Item ID: D350-607-511LG Accept *N900040100* Setup Start *NS1*
Revision ID: Stop *NS2*
Item Name: AS350/AS355 Quick Release Basket/Long Cargo Tube Mounting Provisions, Fits LH/RH (Light Grey)
Start Date: 5/1/2017 Start Qty: 1.00 *1* Cust Item ID:
Required Date: 5/9/2017 Req'd Qty: 1.00 *1* Customer:
Reference: SCHEDULED/C CUSTOM LIGHT GREY
Approvals: Process Plan: [Signature] Date: APR 24 2017 Tooling: Date: Run Start *NR1*
QC: Date: SPC (Y/N): Date: Stop *NR2*

DART SERVICE INSTRUCTION

TO AMEND INSTALLATION INSTRUCTIONS D350-607-3 Rev.D,
INSTALLATION INSTRUCTIONS D350-607-4 Rev. C AND
INSTRUCTIONS FOR CONTINUED AIRWORTHINESS ICA-D350-607 REV. 6
REF TCCA STC: SH94-14
REF FAA STC: SR00213NY
REF EASA STC: EASA.10016996
REF BRAZILIAN STC: 2007S03-03/-04/-05/-06

A	NEW ISSUE	AJS	14.05.16
REV.	DESCRIPTION	BY	DATE
DESIGN	AJS	DART AEROSPACE LTD	
DRAWN	AJS	HAWKESBURY, ONTARIO, CANADA	
CHECKED		DRAWING NO.	REV. A
MFG. APPR.	N/A	DSI 9699	SHEET 1 OF 2
APPROVED		TITLE	SCALE
DE APPR.		LUG REPLACEMENT	NTS
DATE	14.05.16	COPYRIGHT © 2014 BY DART AEROSPACE LTD THIS DOCUMENT IS PRIVATE AND CONFIDENTIAL AND IS SUPPLIED ON THE EXPRESS CONDITION THAT IT IS NOT TO BE USED FOR ANY PURPOSE OR COPIED OR CO

FIGURE 1: INSTALLATION OF D4775-041 FWD STRUT

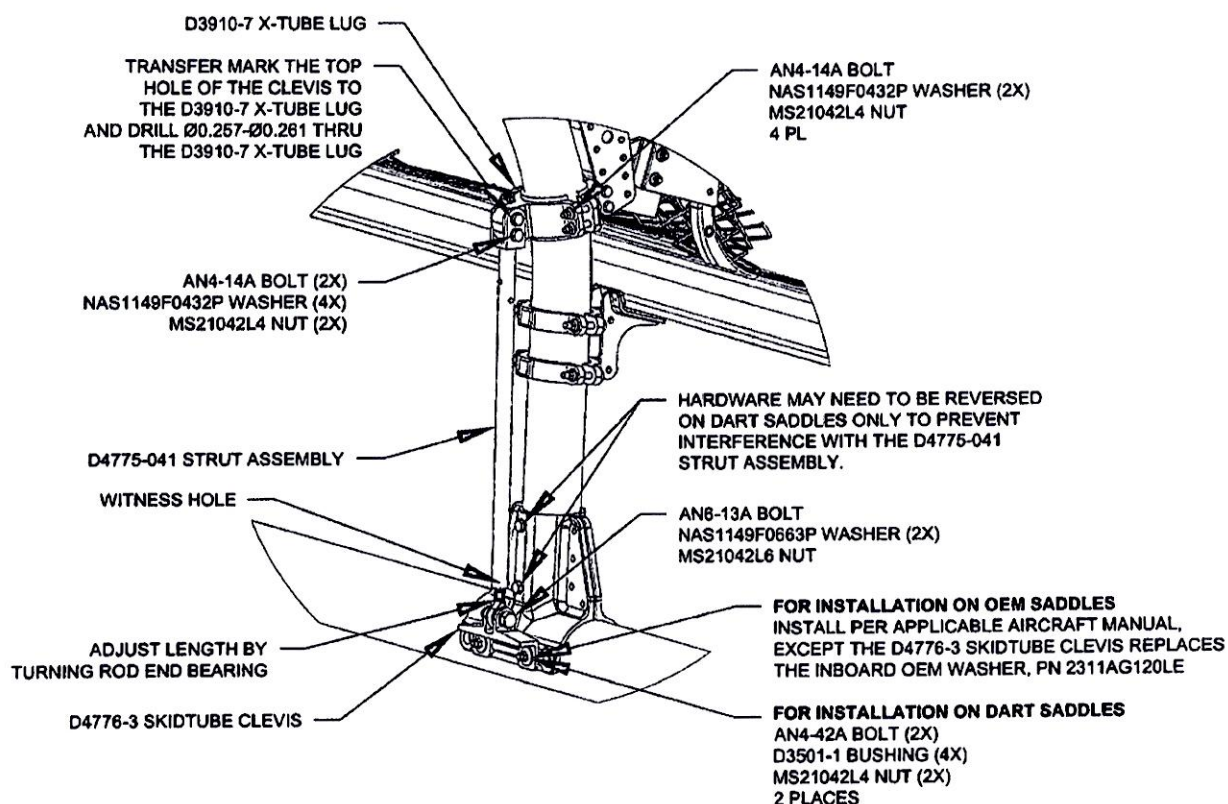
3.1 Substitute the Forward Lower D3910-5 X-Tube Lug with the D3910-7 X-Tube Lug as shown in Figure 1.

3.2 Install the forward D4775-041 Strut Assembly. Transfer mark from the upper hole on the clevis of the D4775-041 Strut Assembly to the D3910-7 X-tube Lug and drill thru the lug $\varnothing 0.257$ - $\varnothing 0.261$ as shown in Figure 1. Touch up chemical conversion coating per MIL-DTL-5541. Check the witness holes located at the bottom end of the D4775-041 Strut Assemblies to ensure that the thread from the rod end extends past the witness hole.
Torque MS21042L4/-4 nuts to 50-70 in-lbs (5.7-7.9 N-m). Torque MS21042L6/-6 nuts to 160-190 in-lbs (18.1-21.5 N-m).
